Architect's Supplemental Instructions

Architect's ASI No: 048

Project:
Webster University
Interdisciplinary Science
Building

Date Issued: 01/27/2017

1 LEVEL 03 - AREA A - FLOOR PLAN - POWER AND AUXILIARY
1/8" = 1'-0"

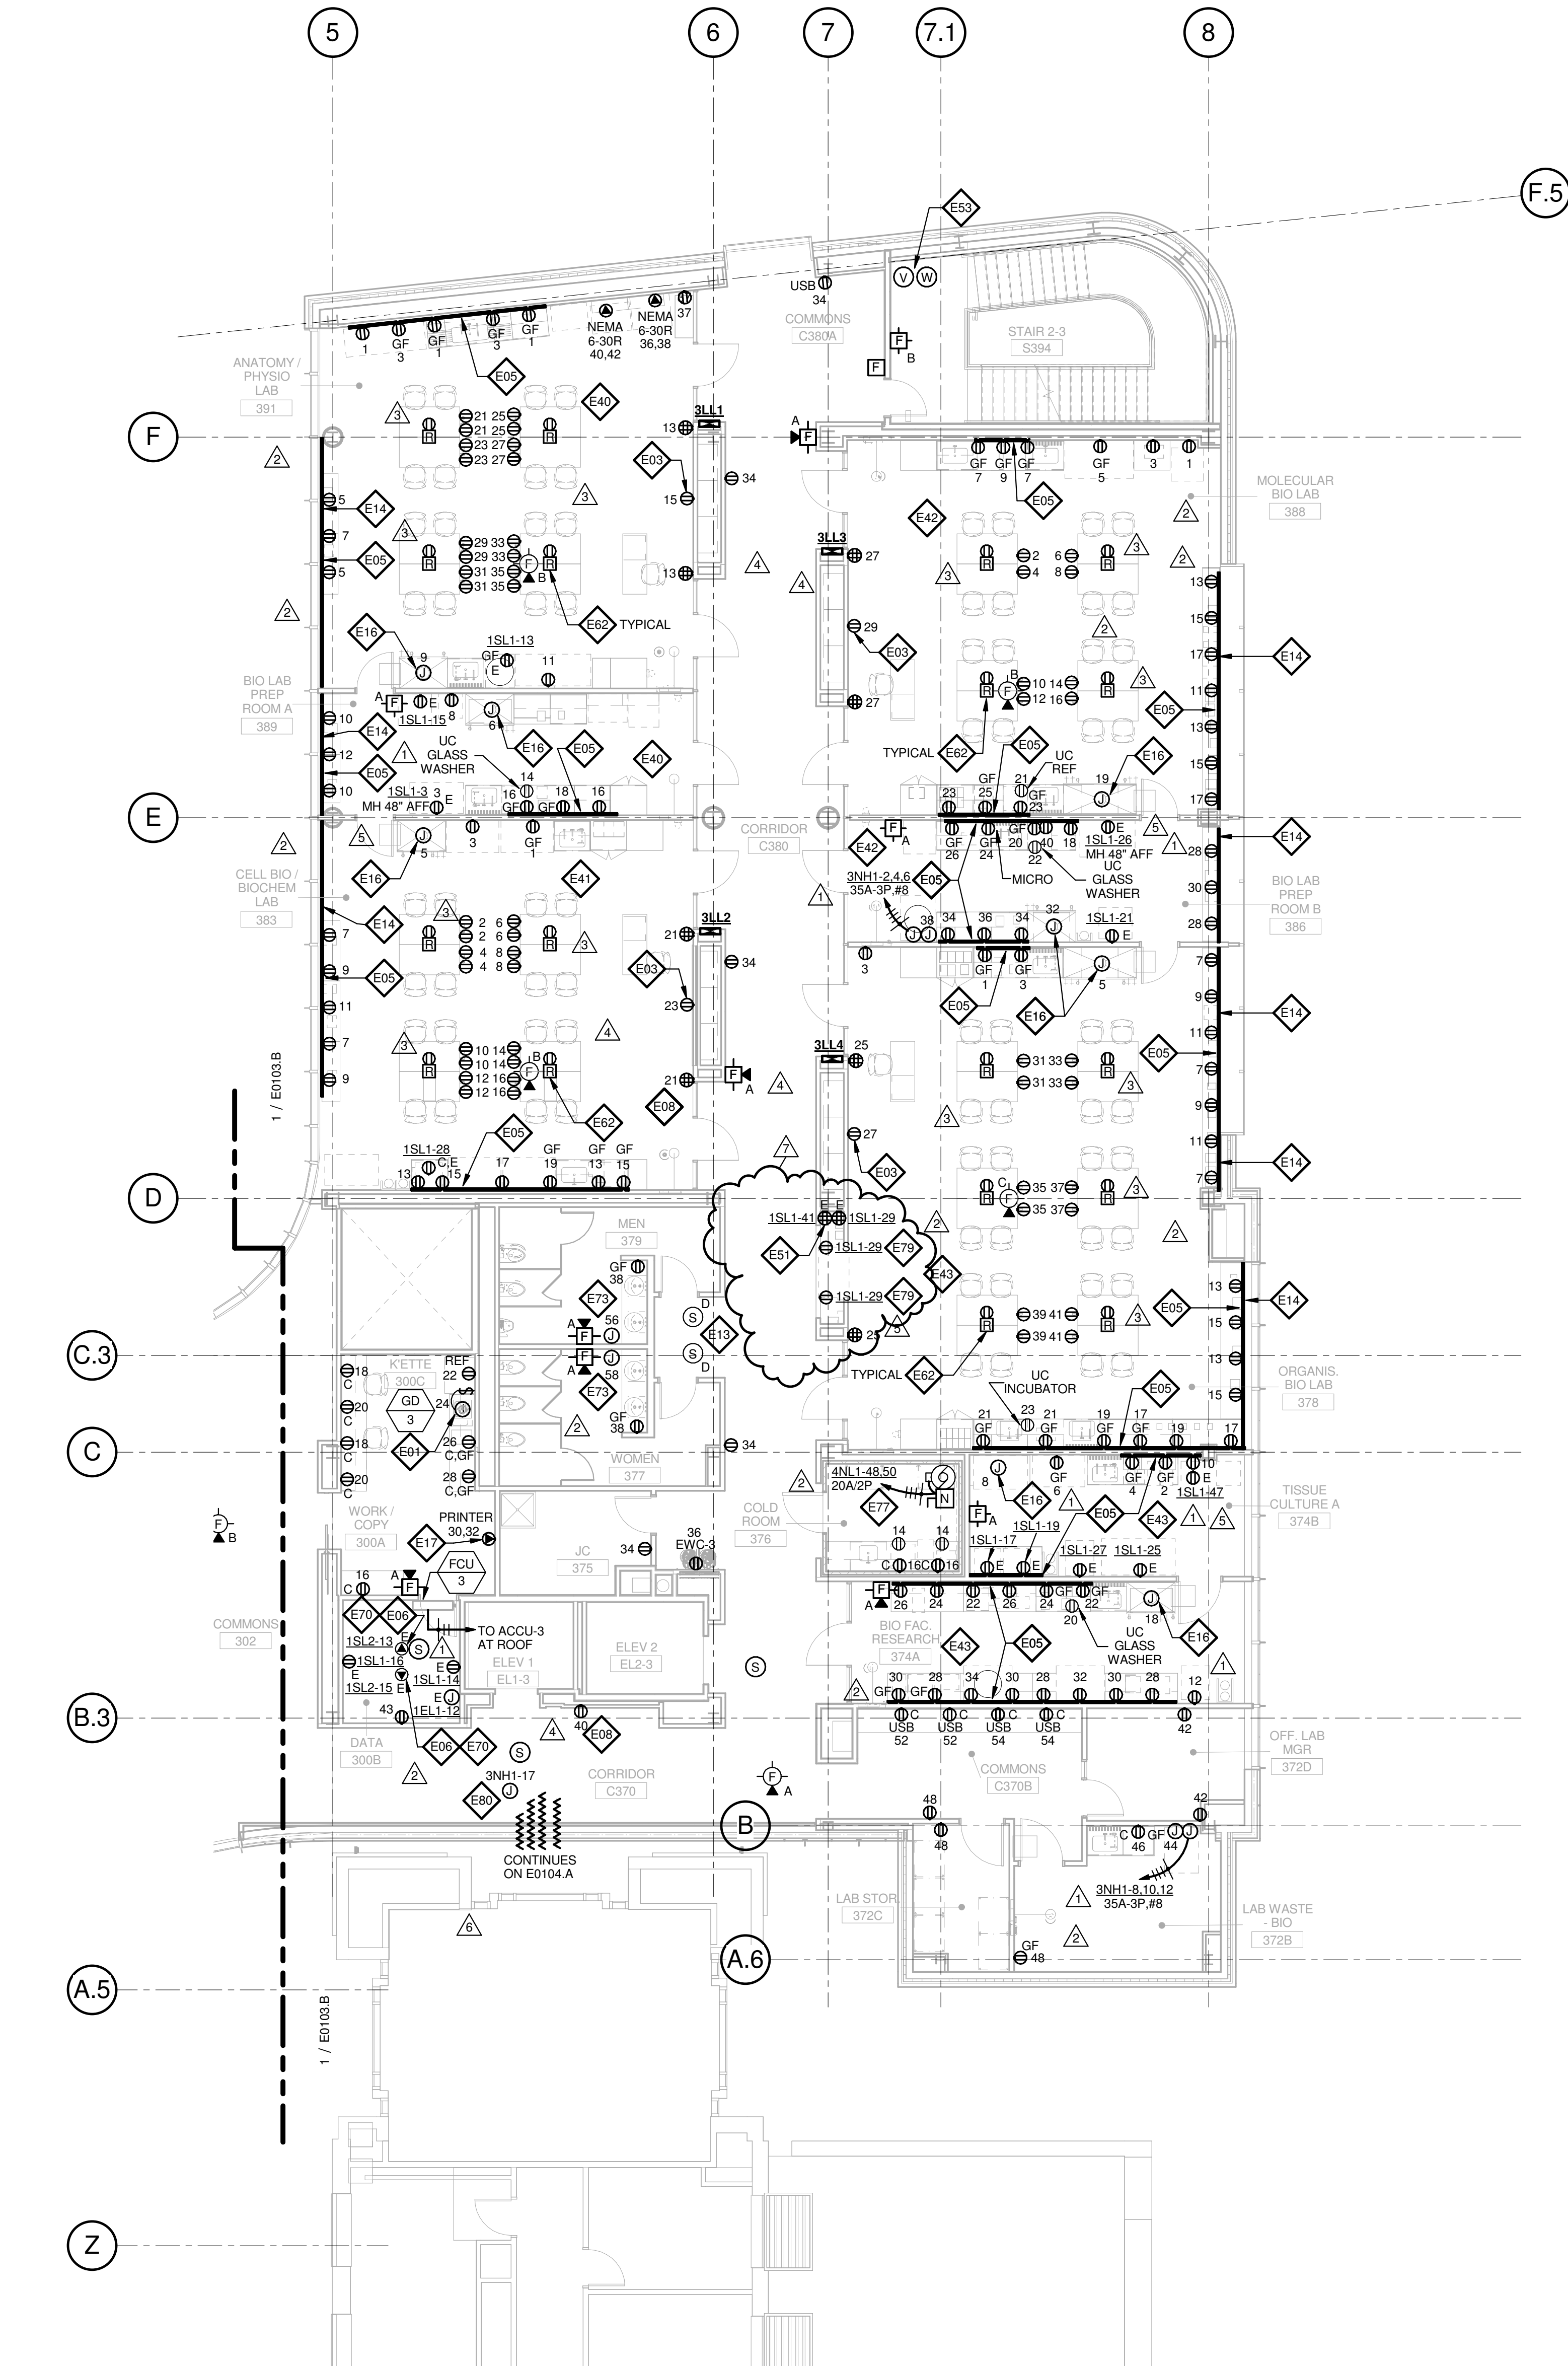
- In Organism Bio Lab 378, remove one ceiling mounted aquarium receptacle on circuit 3LL4-29 and associated branch circuit. Connect remaining two ceiling mounted receptacles to circuit 1SL1-29.
- In Organism Bio Lab 378 relocate wall mounted aquarium receptacles to north wall.
